COUNCIL MEETING

CONCEPT PLAN

South Creek

January 12, 2021

☐ Stormwater Management Utility Advisory Board

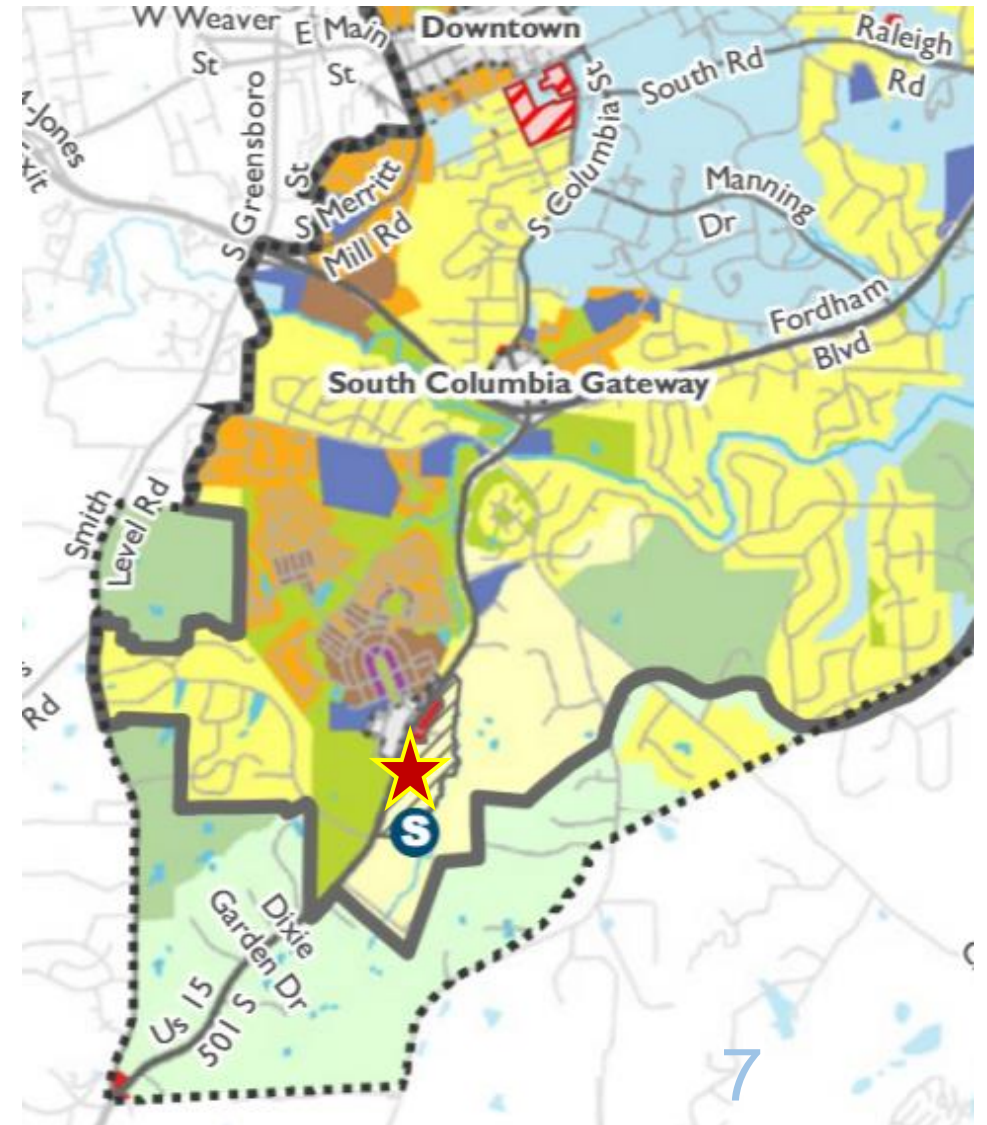
- More info needed on steep slopes disturbance, RCD encroachment, outlet location, soil infiltration
- Locate dumpsters away from streams and drainage features
- Consider underground detention to allow more tree preservation
- Reduce / limit impervious surfaces

Obey Creek Devt Agmt (2015)

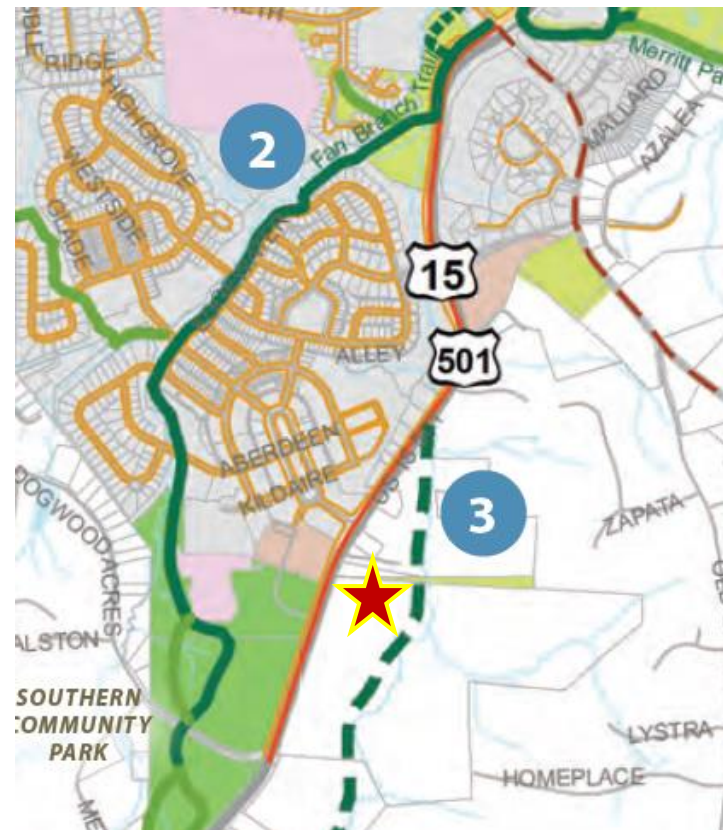
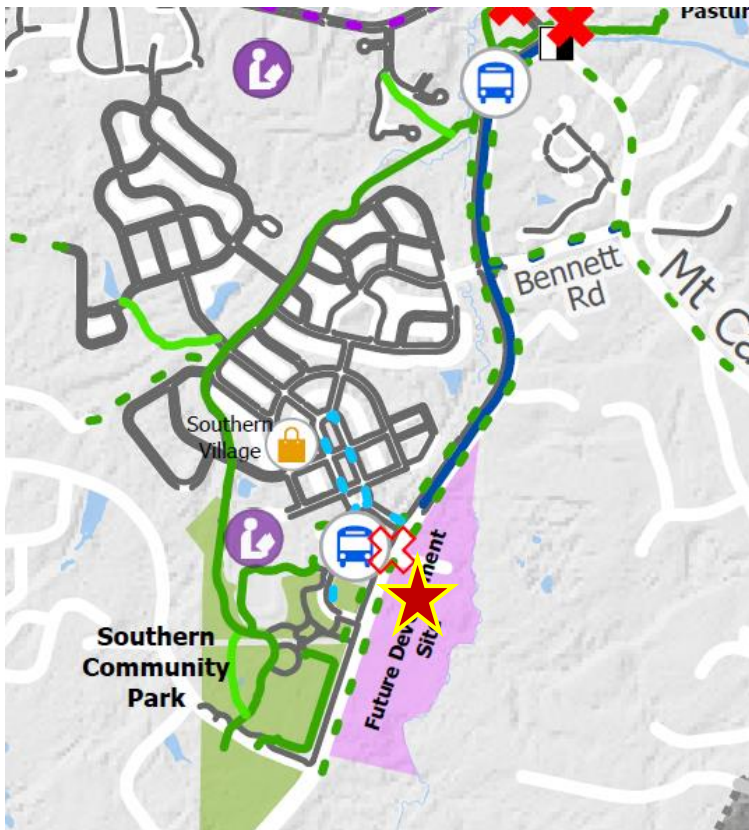
- Multifamily Residential, Retail, Office, Hotel
- 600K-1.6M sq ft of development, with requirements for mixing uses
- Up to 700 dwelling units
 - Age restriction for at least half of rental units
 - Affordable units: 15% of for-sale, 5% of rentals
- Wilson Creek Preserve (85 acres) and other open space requirements
- Specific improvements and standards for:
 - Transportation
 - Design
 - Stormwater
 - Various Other
